DeKalb County Historic Preservation Commission

Staff Report

- C. 1195 Clifton Road, Amanda Johnson for Small Carpenters at Large. Replace windows on the side and rear of a historic house. **1248130.**

A1

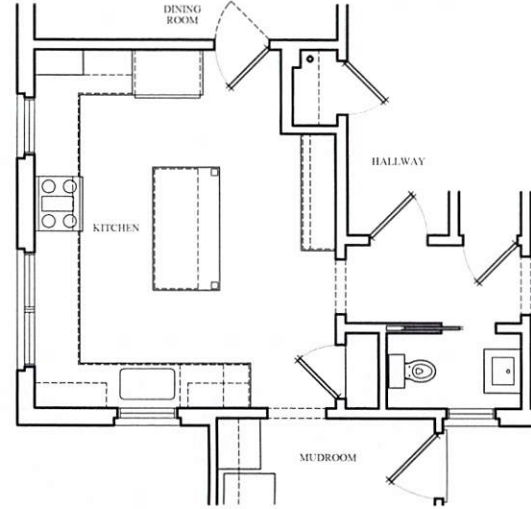
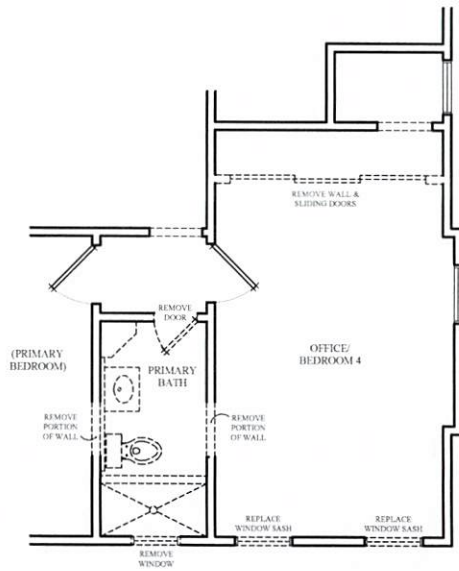
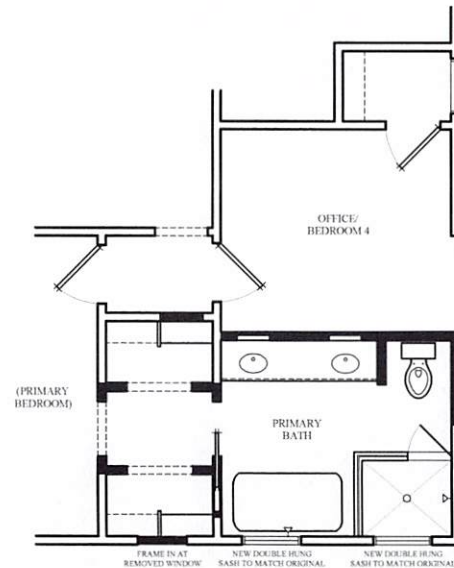
The applicant proposes replacing 5 nonhistoric windows and removing the existing vinyl awning window. A total of three vinyl windows on the rear of the house and the two vinyl windows on the upper level of the front façade will be replaced. New windows would be wood, simulated lites with $\frac{5}{8}$ window design. The vinyl awning window on the upper level of the house will be removed.

Approve. The proposed changes do not appear to have a substantial adverse effect on the property or the district. This application appears to meet the guidelines and the staff recommends approval.
